ADDENDUM NUMBER 2 – JULY 22, 2024

AUGUSTA REGIONAL LANDFILL – LFGCCS EXPANSION

SOLID WASTE PERMIT NO. 21 AND NO. 585

Prospective Bidders are hereby advised of the following revisions to the Bid Documents for the subject Project:

SHEET TITLE: PROPOSED LFG HEADER PROFILE 1
SWP #21 - FILL AREA 6

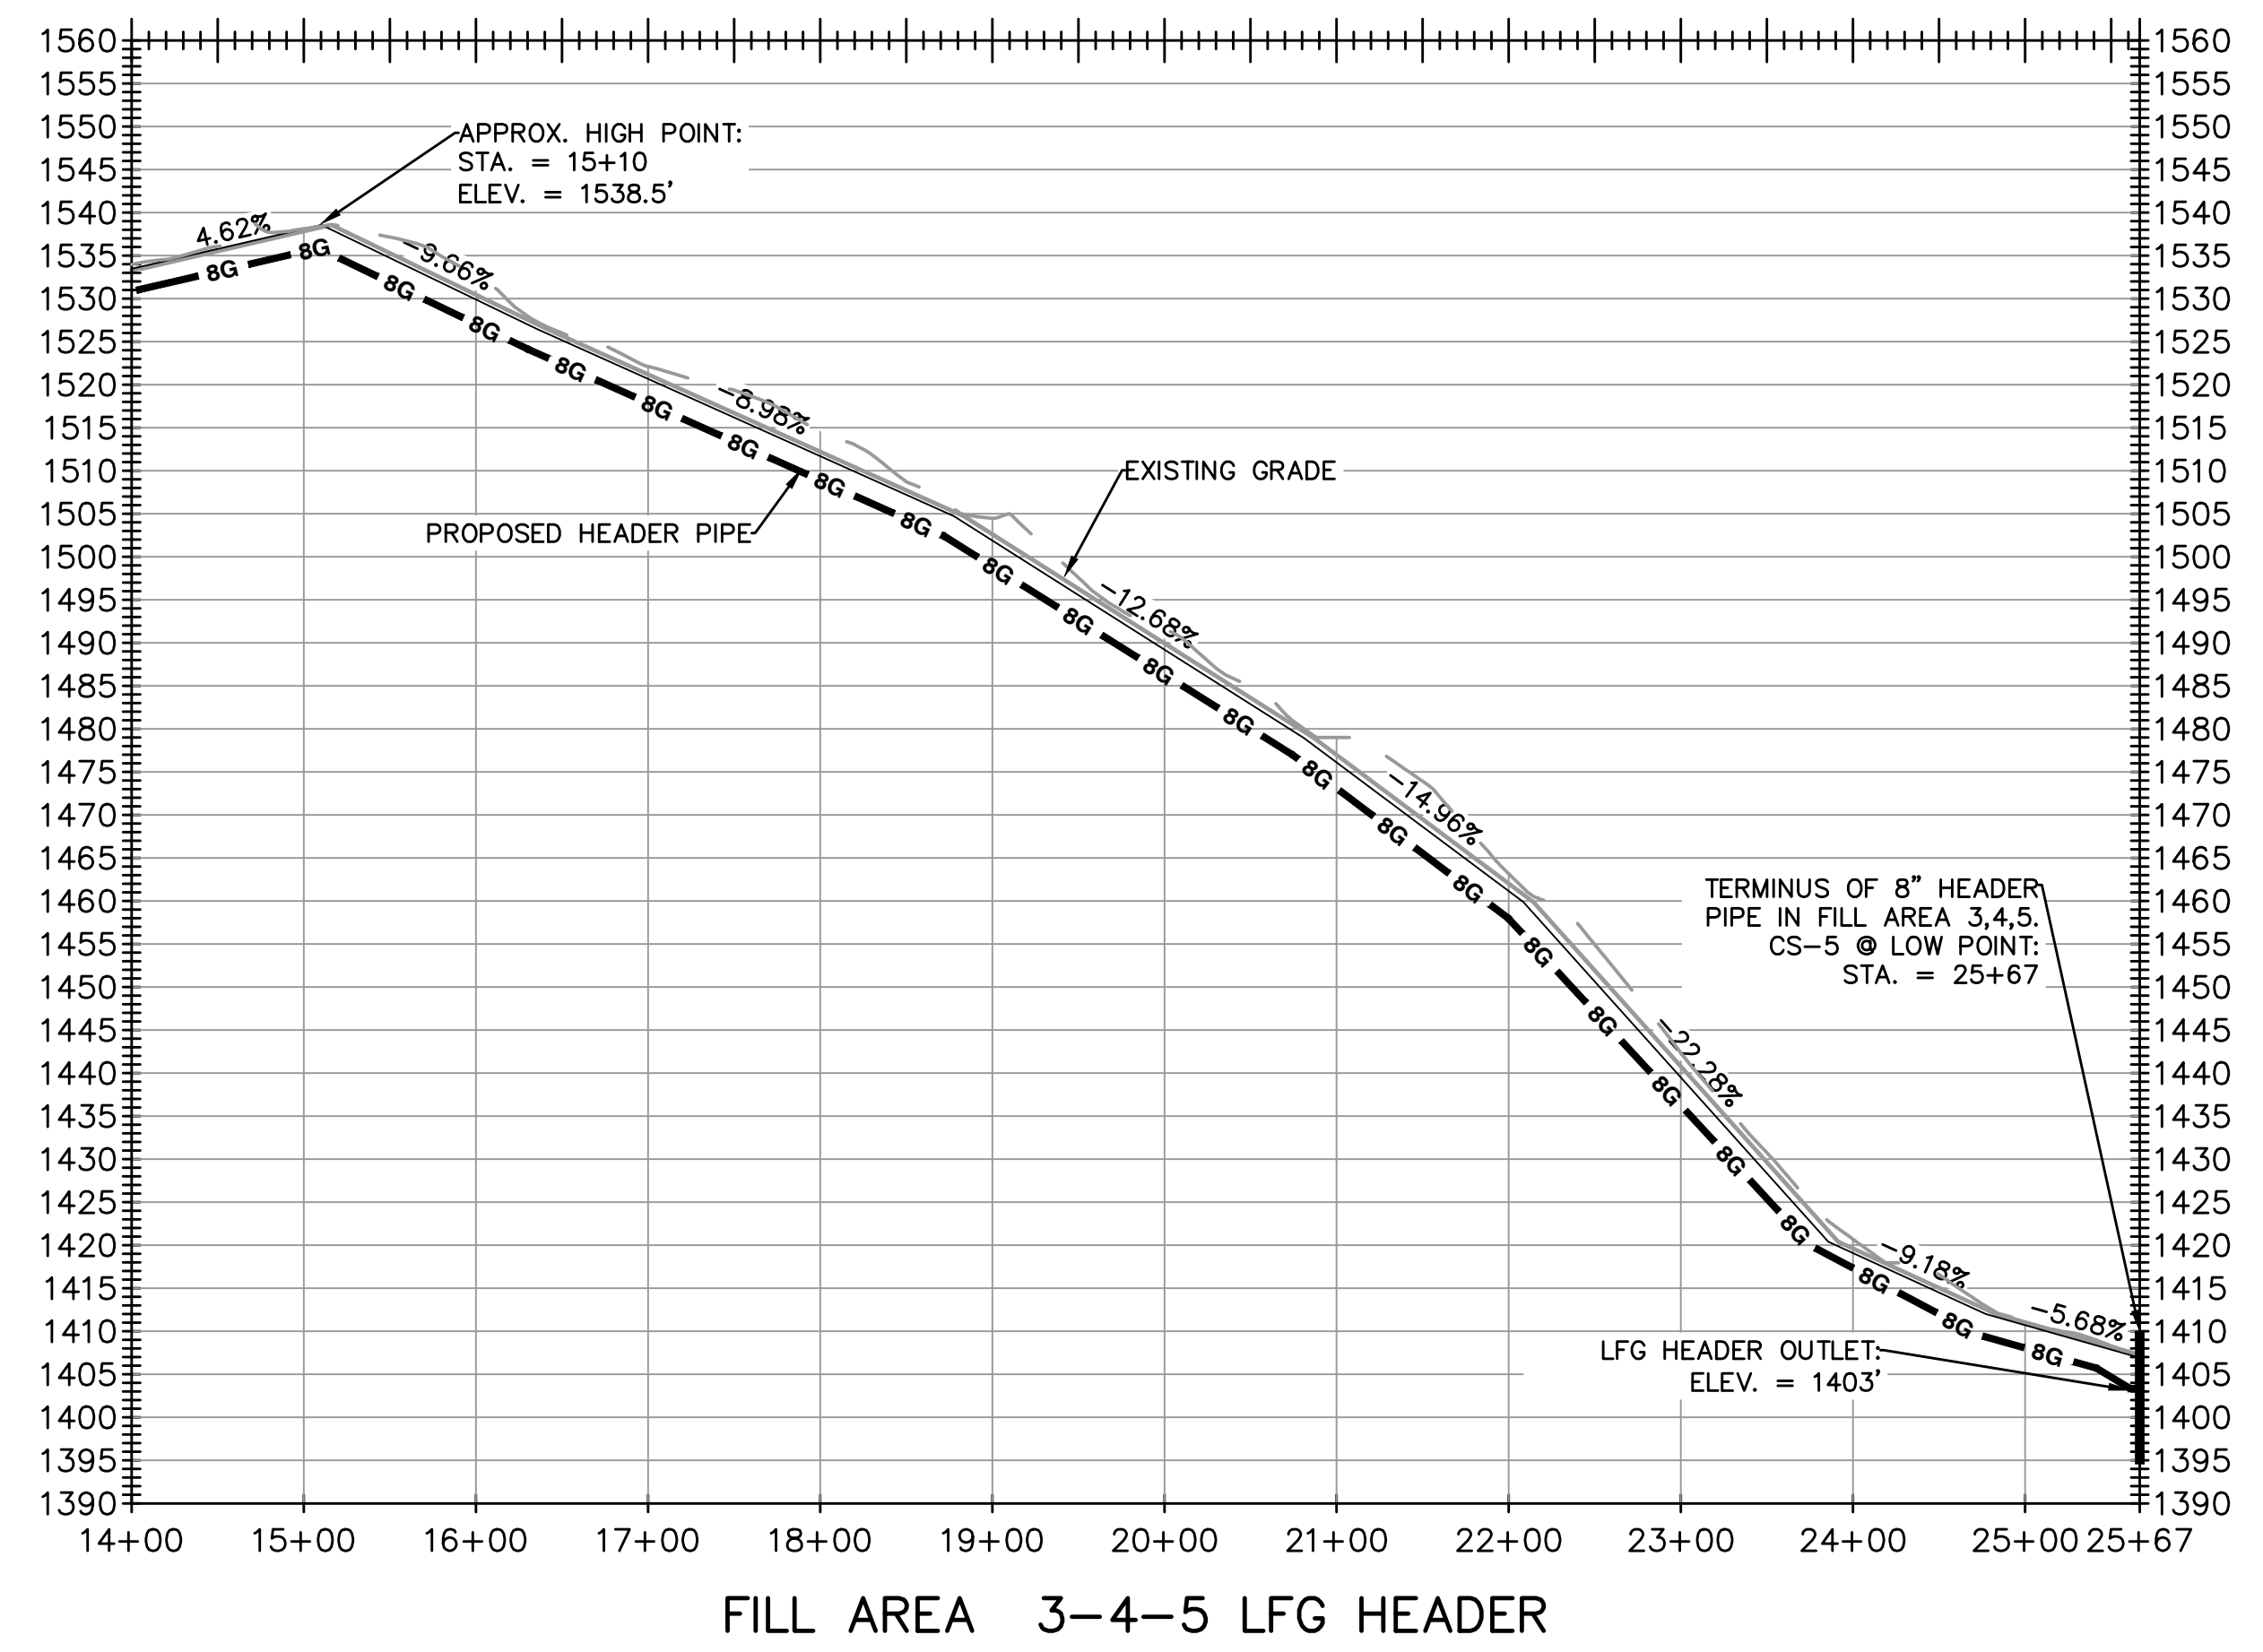
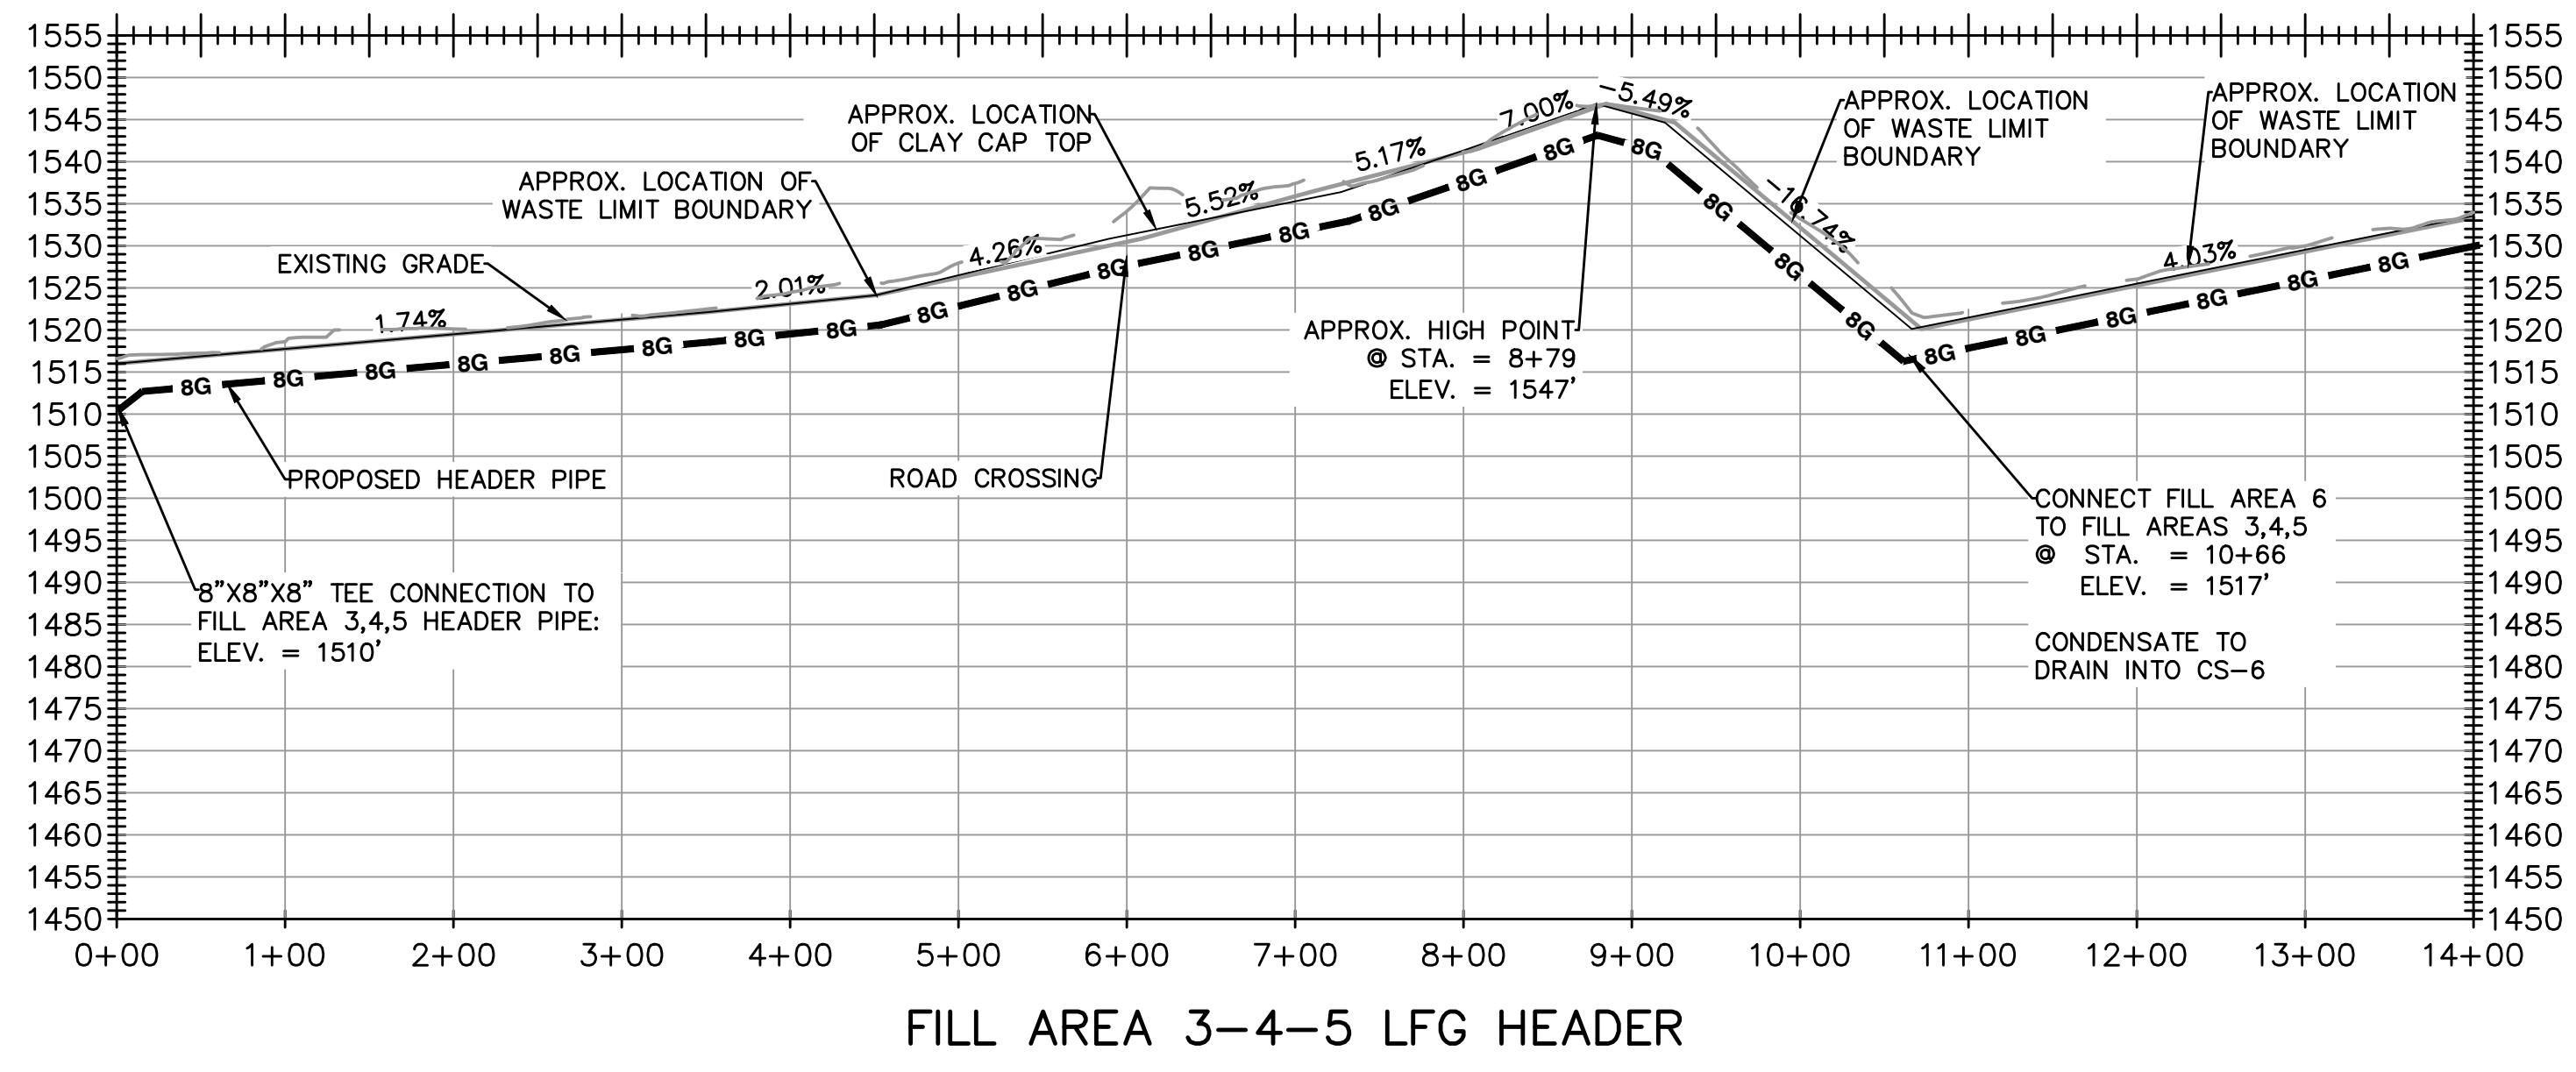
- Profiles on Sheet No. 7A, Sheet No. 7B, and Sheet No. 7C have been revised to reflect a minimum pipe depth of 3 feet. Additional notes have also been added to these sheet.
